## REMARKS / ARGUMENTS

The following changes were discussed in the 03 August 2004 teleconference with the Examiner:

TITLE changed  
w/ words  
Replacement  
Sheet

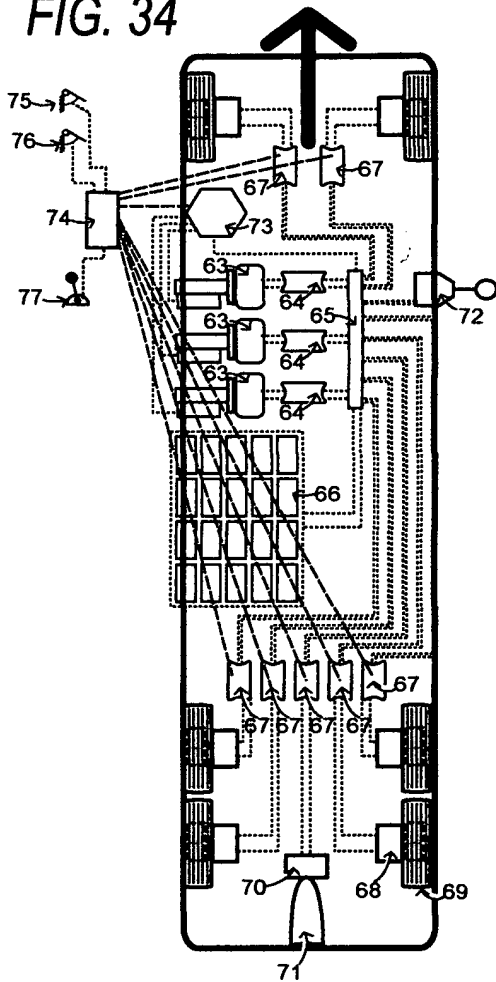
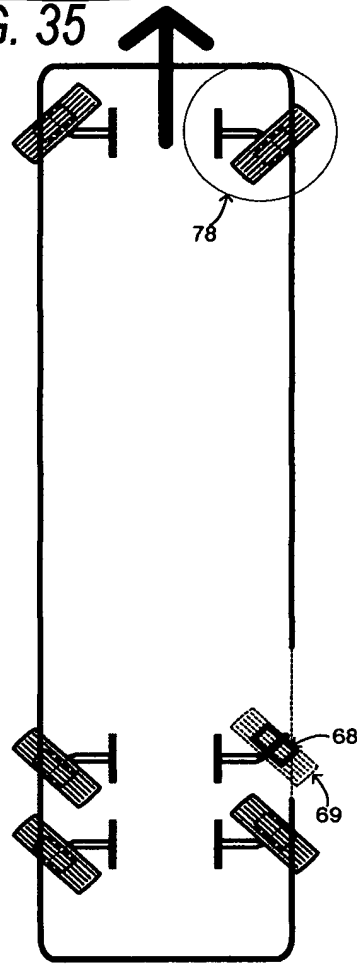
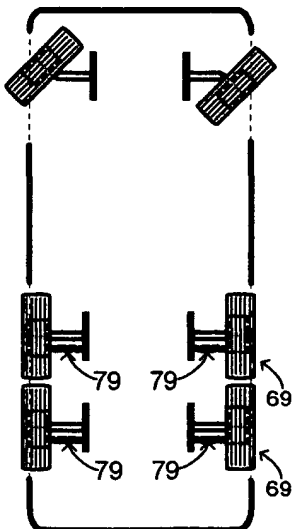
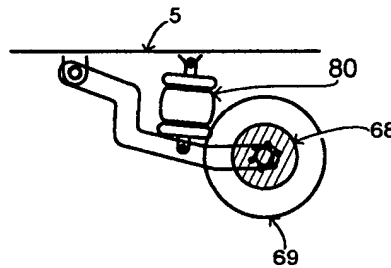
On Drawing Sheet 8 of 8, the heading was changed in response to **Office Action Item 2**.
